RF TEST REPORT

Applicant Kizy Tracking SA
FCC ID 2AGPEWT2
Product Tracker
Model K-2
Report No. R1903A0135-R2
Issue Date April 26, 2019

K-2 Difference statement

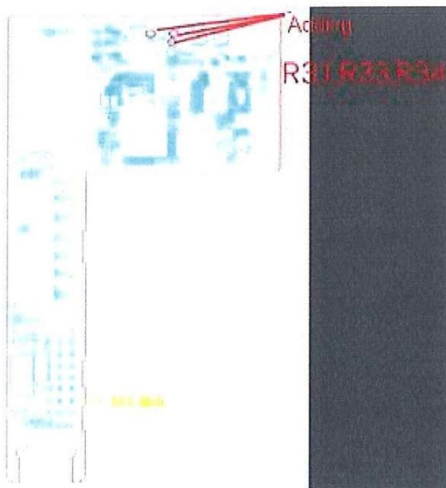
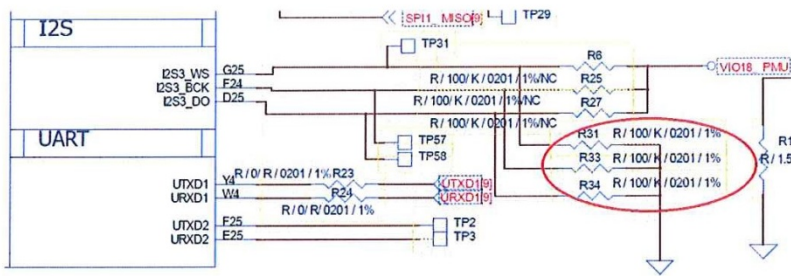
1. Added 3 resistors to confirm the version,R31,R33,R34,

1	WT2N	Hardware Ver. Control	Add pull low resistance to check HW Ver. MTK U402 I2S3_WS(G25), I2S3_BCK(F24),I2S3_DO(D25), PCB version,PULL HIGH100KΩ, VIO18_PMU, with PULL LOW 100KΩ to GND Actually the pieces are: U402_I2S3_WS(G25),PULL LOW U402_I2S3_BCK(F24),PULL LOW U402_I2S3_DO(D25),PULL LOW
---	------	-----------------------	--

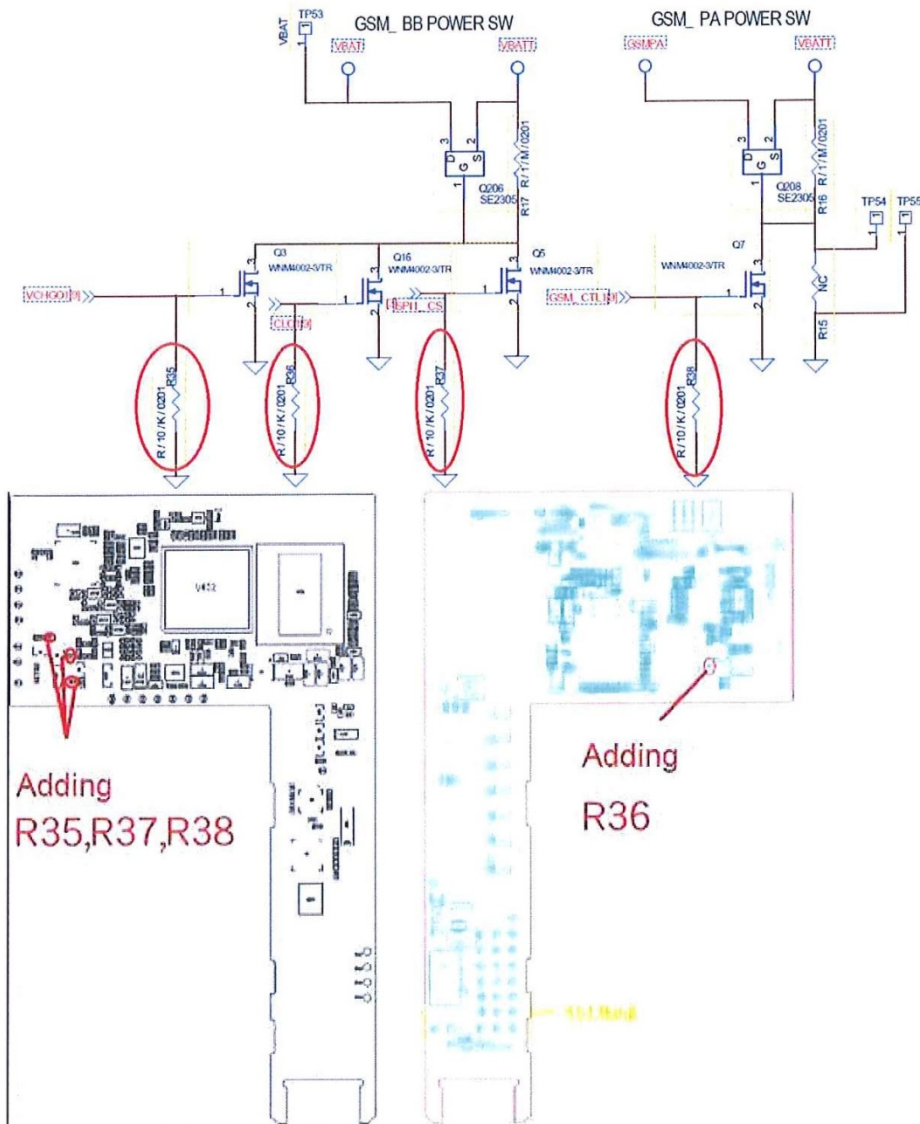
2	WT2N	Power Leakage When Off Switch	<p>Add pull low resistance to shut down VBATT power Because it cannot be completely shut down, it must be</p> <ol style="list-style-type: none"> 1.Q3' s G PIN parallel 10K Ω to GND 2.Q160' s G PIN parallel 10K Ω to GND 3.Q5' s G PIN parallel 10K Ω to GND 4.Q7' s G PIN parallel 10K Ω to GND
---	------	----------------------------------	--

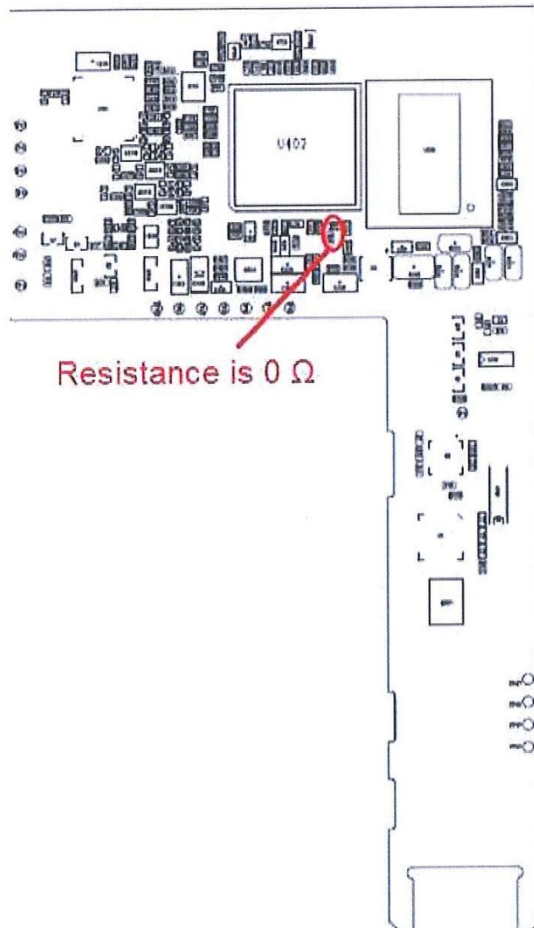
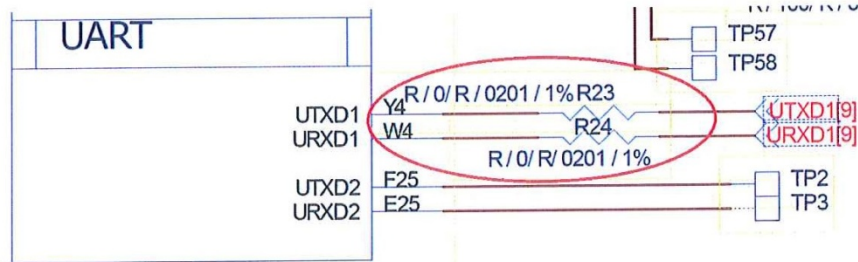
3	WT2N	UART Slew Rate	Resistance value change to 0Ω For UART R23 and R24 Change the resistance to 0Ω
---	------	----------------	---

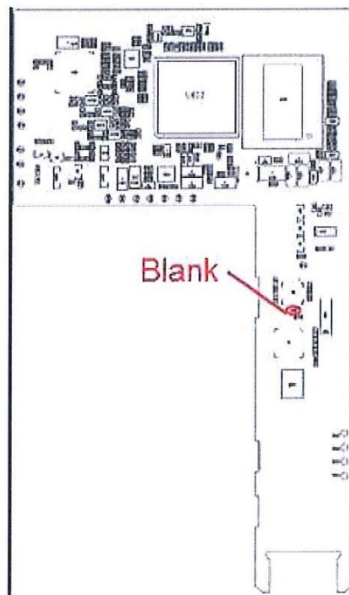
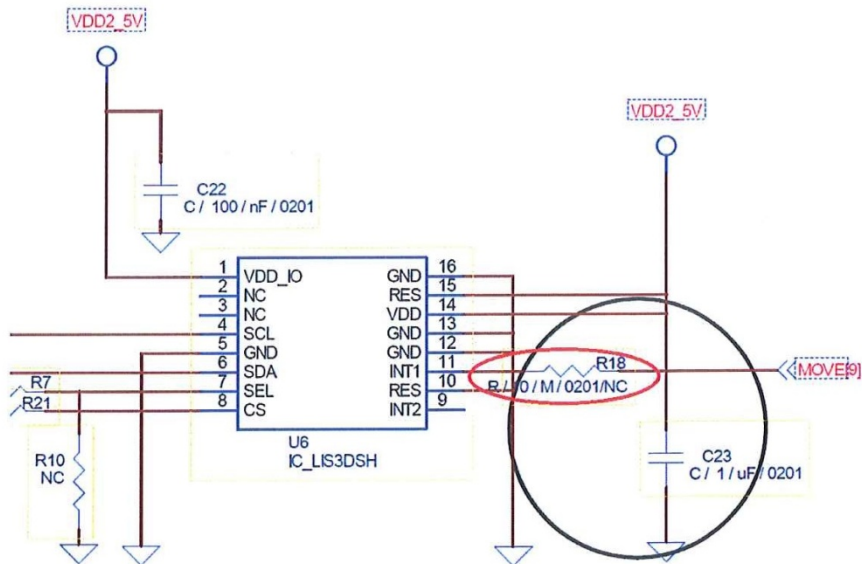
4	WT2N	Accelerometer misfunction	Take off R18
---	------	---------------------------	--------------

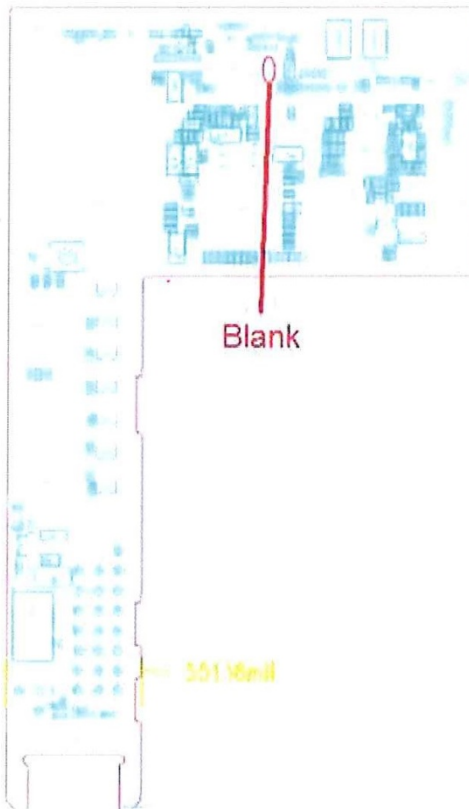
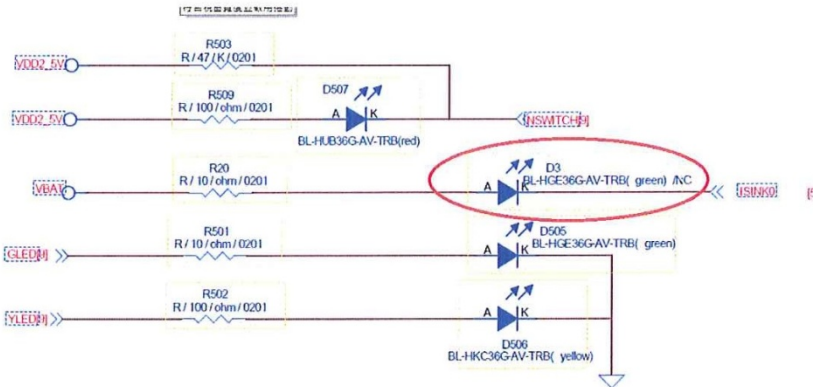
5	WT2N	4th LED removed	Take off D3
---	------	-----------------	-------------

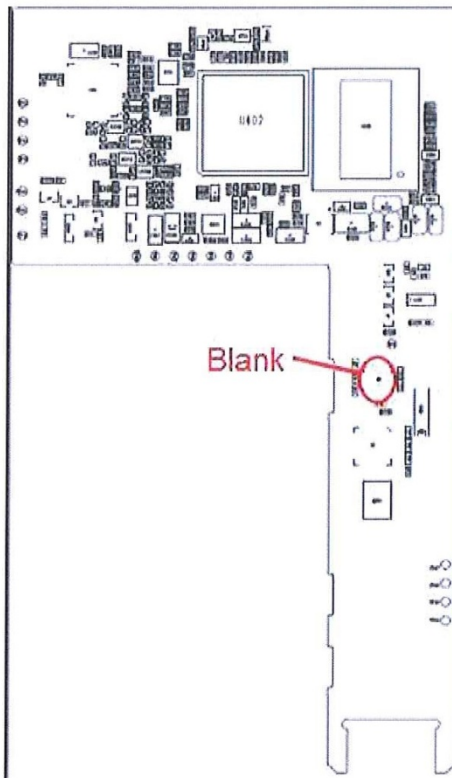
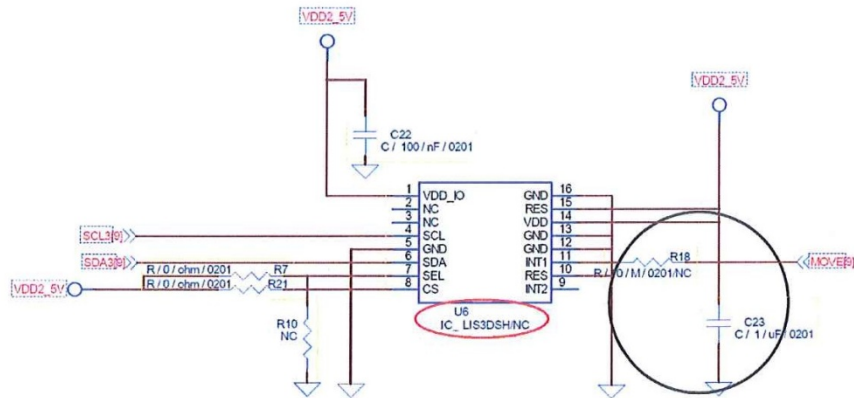
6	WT2N	Accelerometer removed	Take off U6
---	------	-----------------------	-------------
